Geotechnical Engineering Report

Proposed Acorn Valley Development

83 Christie Drive, Dorchester, Ontario

Revised Report

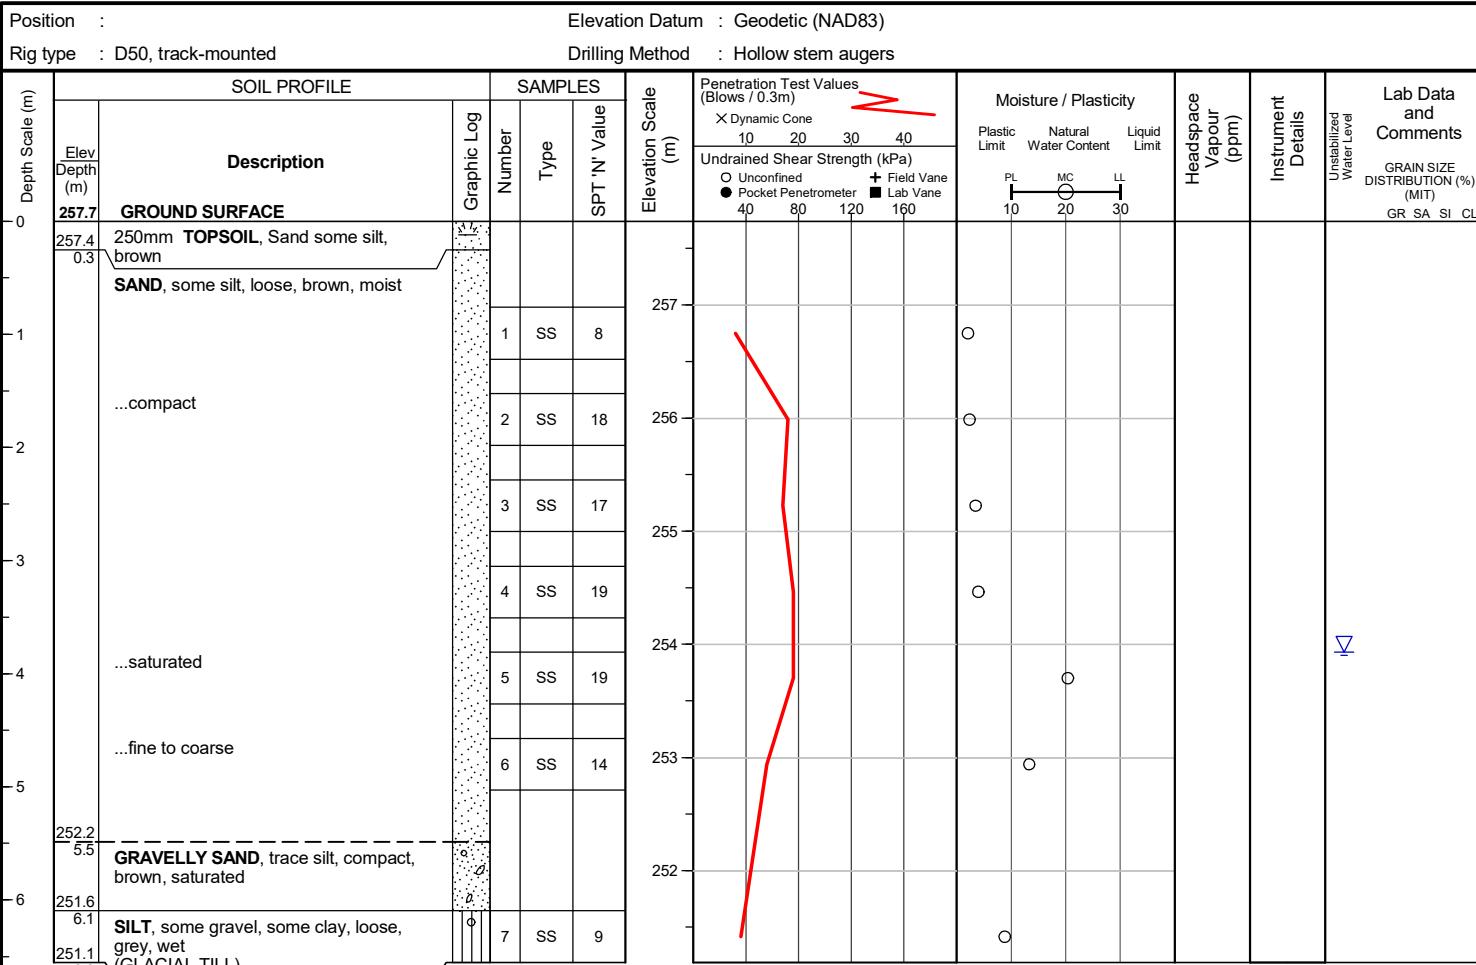
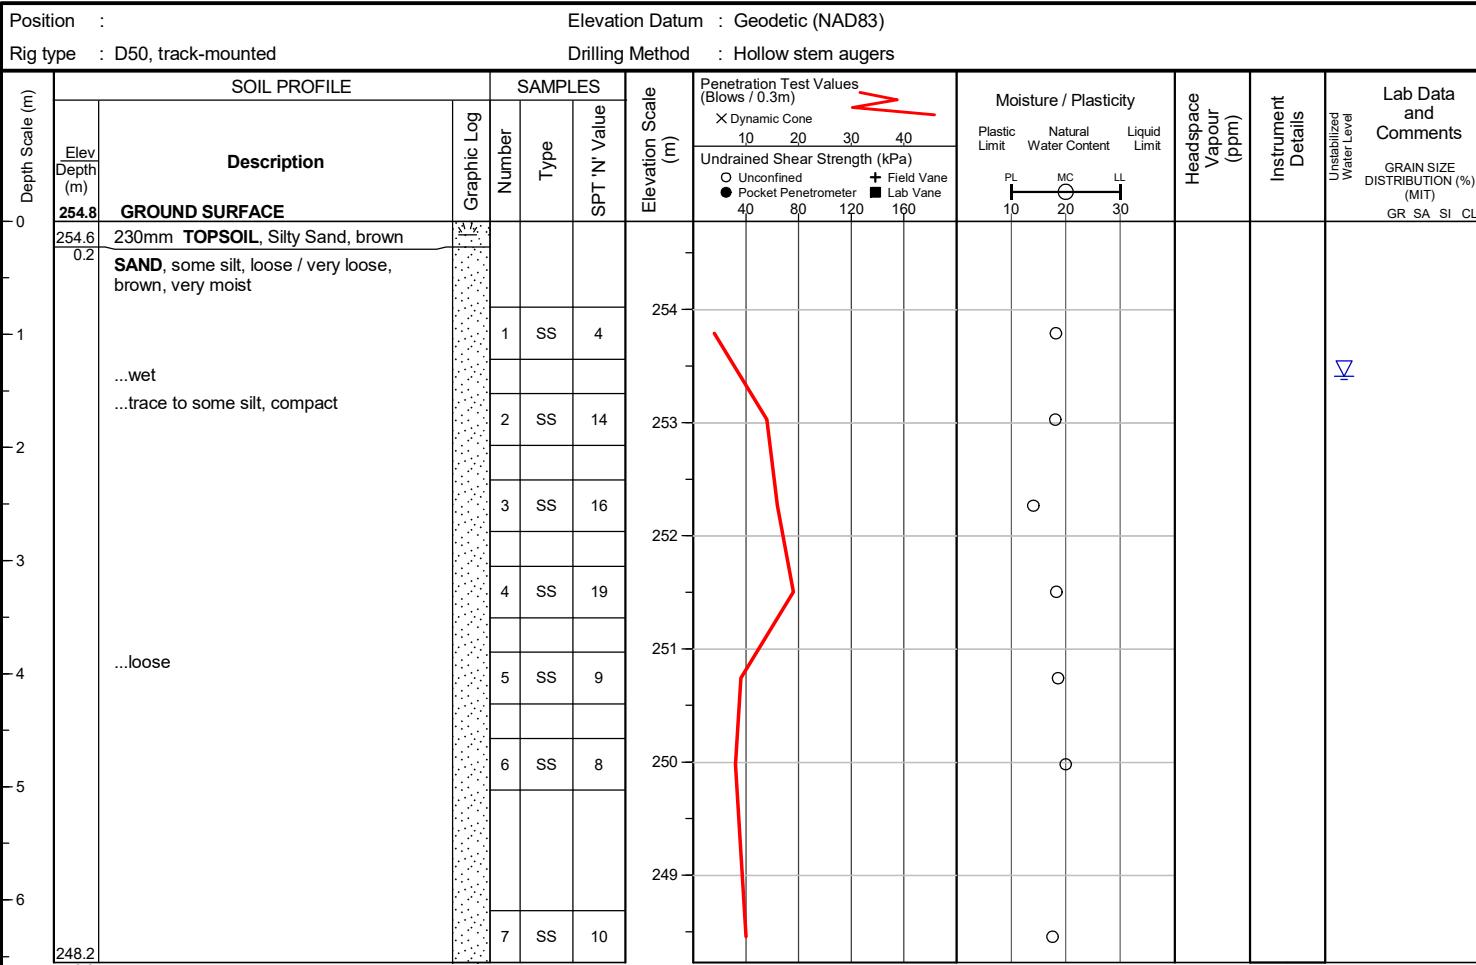
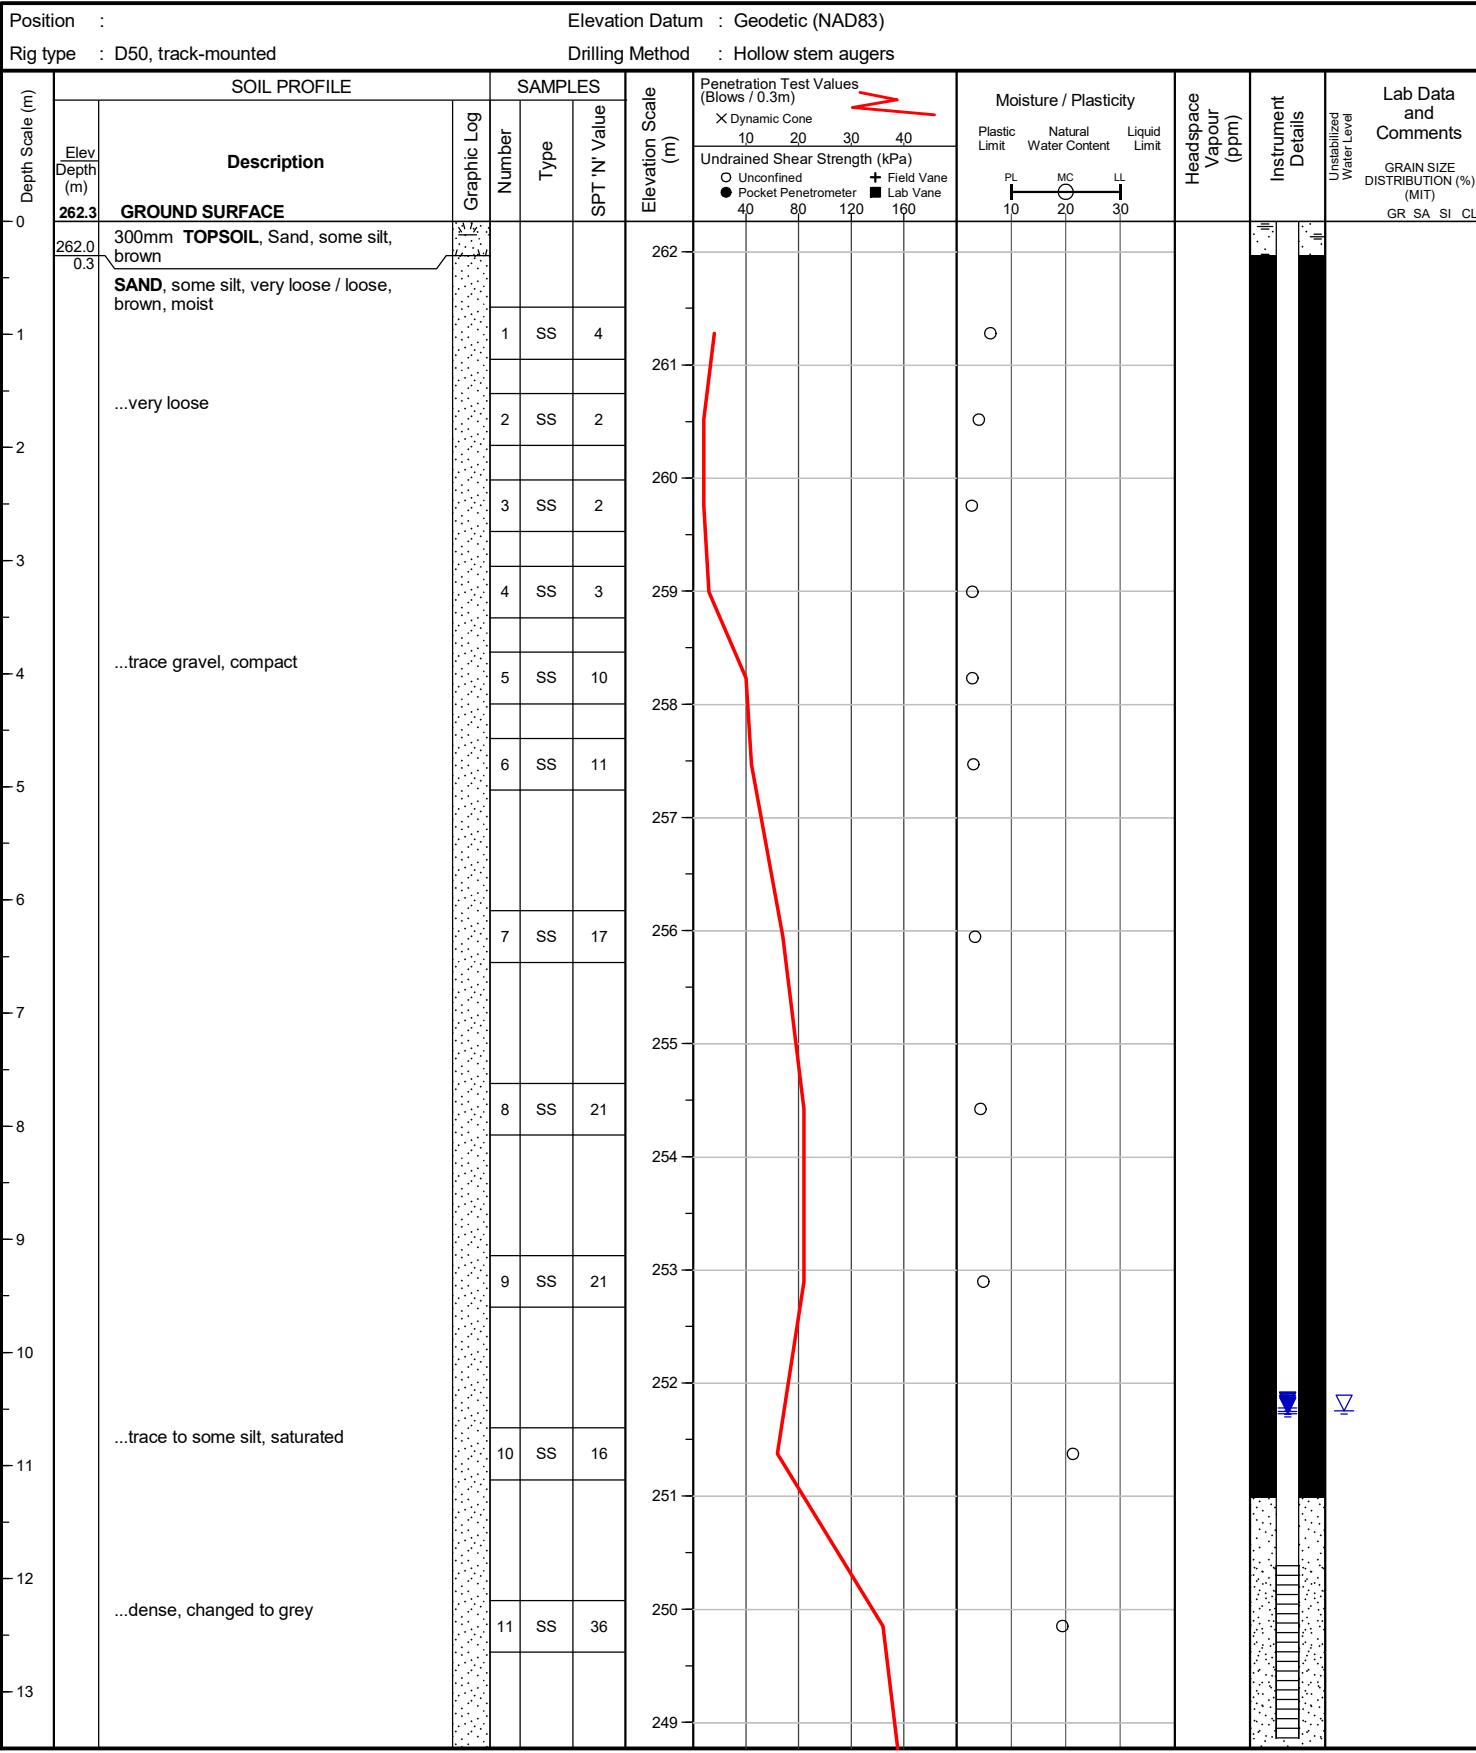
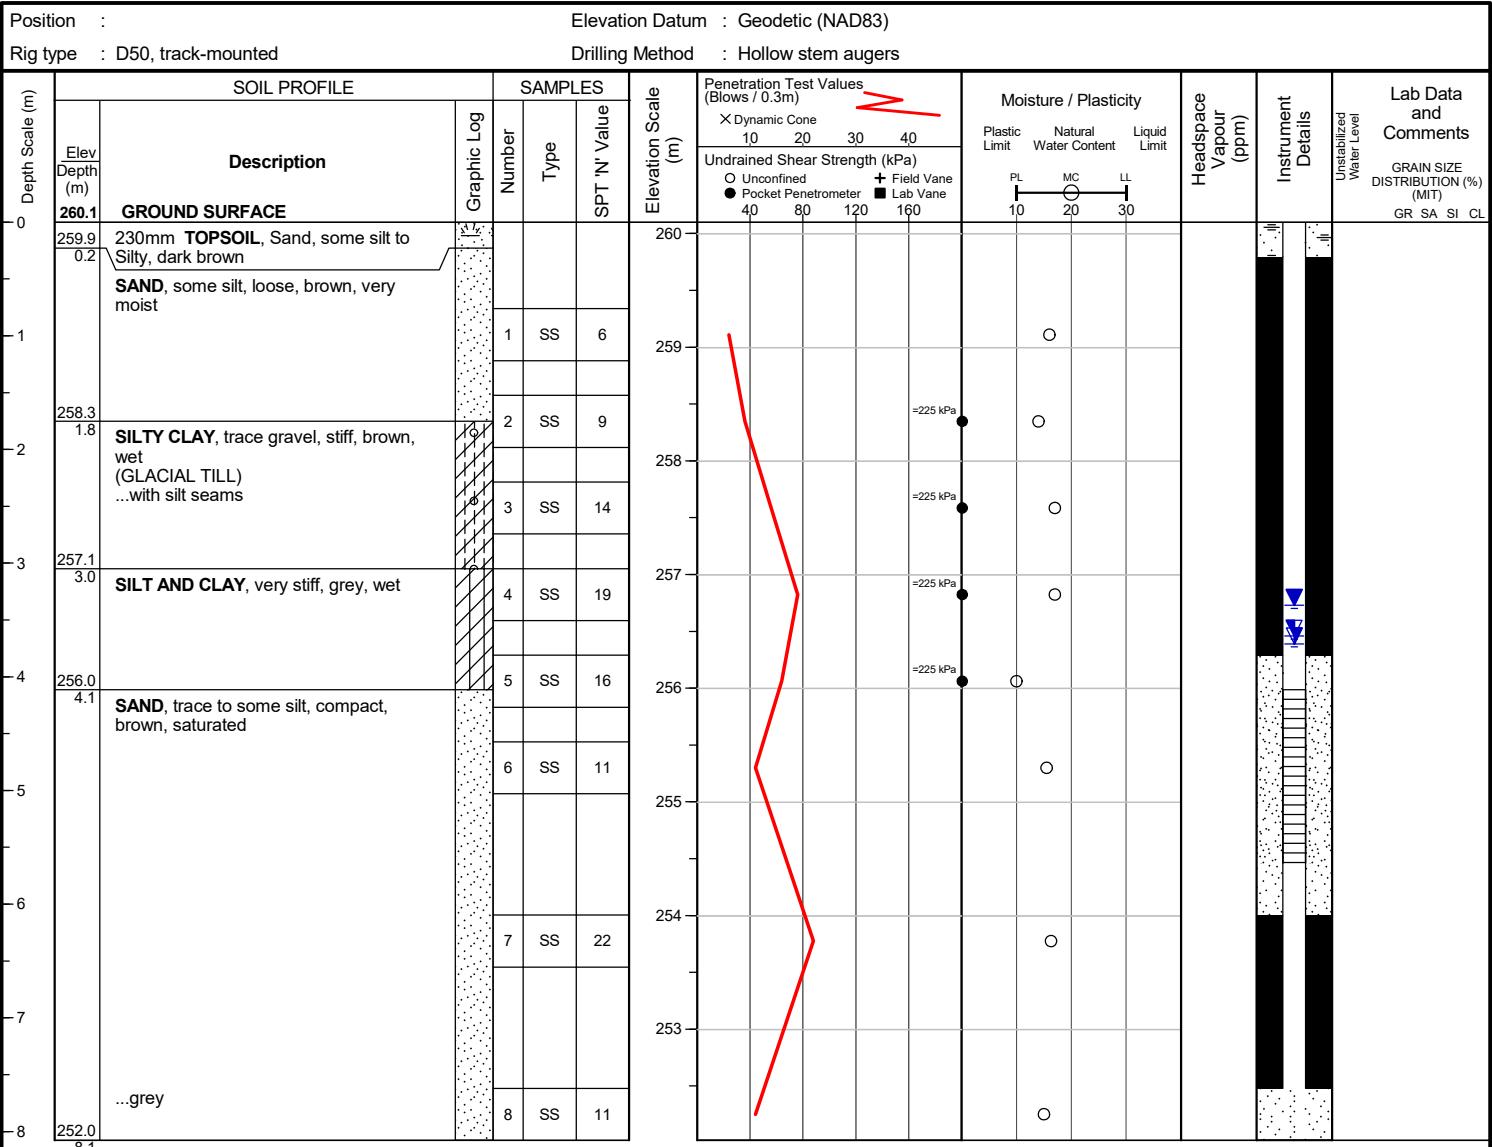
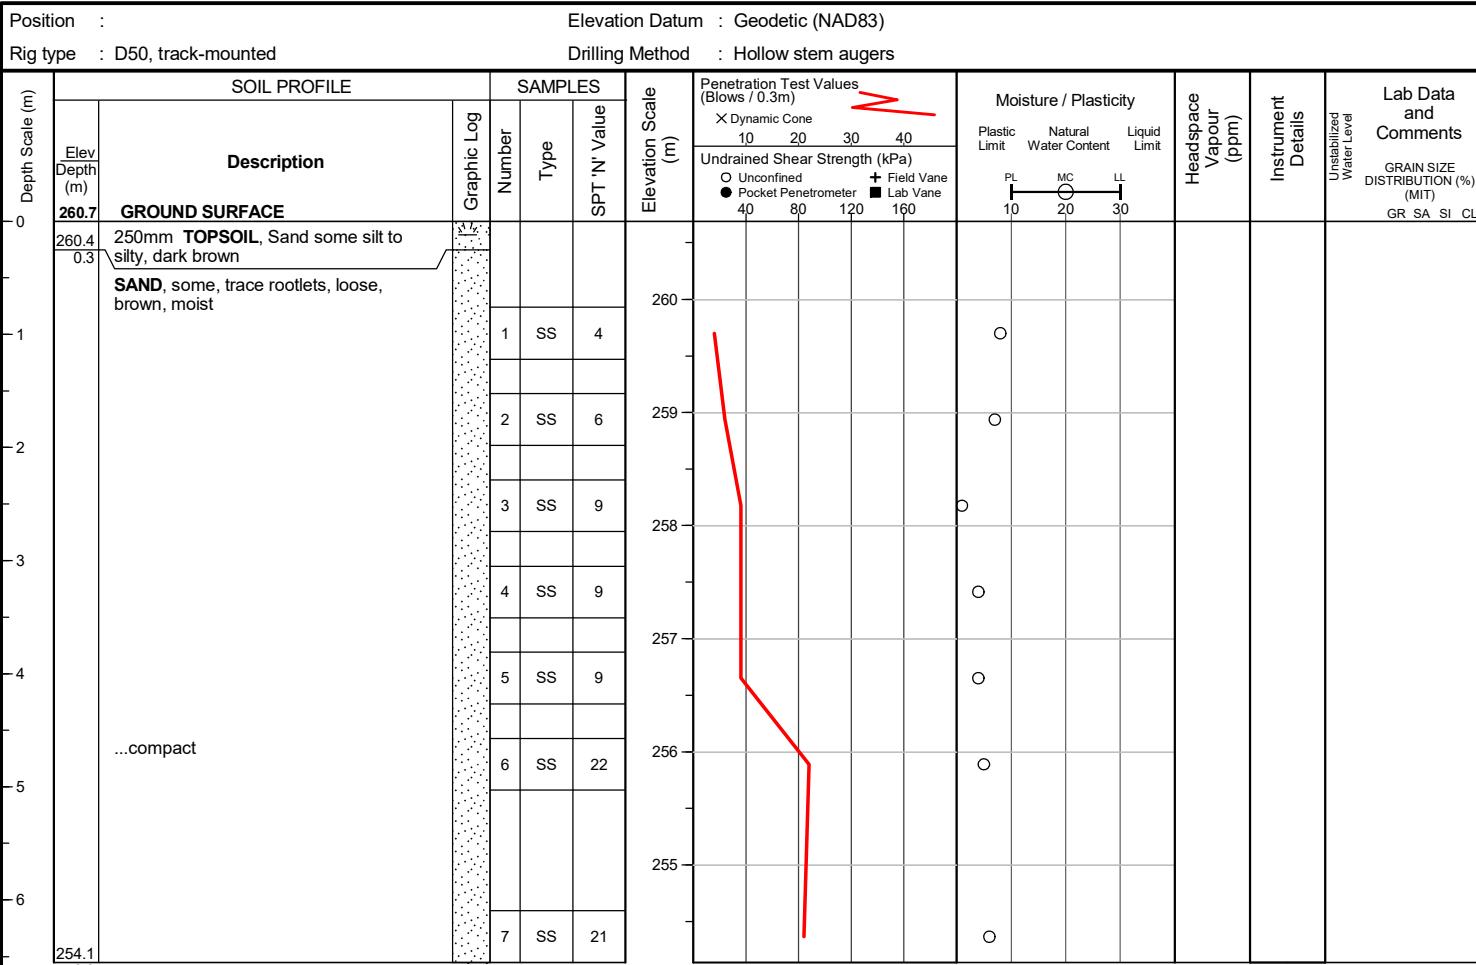
ITEM No.	Section	CLIENT COMMENTS	Englobe Response	CLIENT DECISION/CONCLUSION
G5		The log for borehole 10 in Appendix C shows the groundwater level at approximately 2.25 m below ground but is stated as 3.23m in the body of the report. Please confirm.	Updated borehole logs.	
G6		Please confirm that the 8 cross-sections shown are considered critical sections of the corresponding slopes.	As summarized in Table 5, the slope at Section 5-5' was considered the critical slope section and was therefore selected for analyses.	
G7		Please also include the 6m erosion access allowance on the detailed cross-sections.	Updated as requested	
G8	5.5	states that based on the findings of the analysis the proposed trail (in the vicinity of cross-section A-A') can be safely constructed without adversely affecting the long-term stability of the valley slope. No risk to life or property damage is anticipated. Please include decision on watermain as well as the trail.	Revised accordingly. Added recommendations for slope restoration.
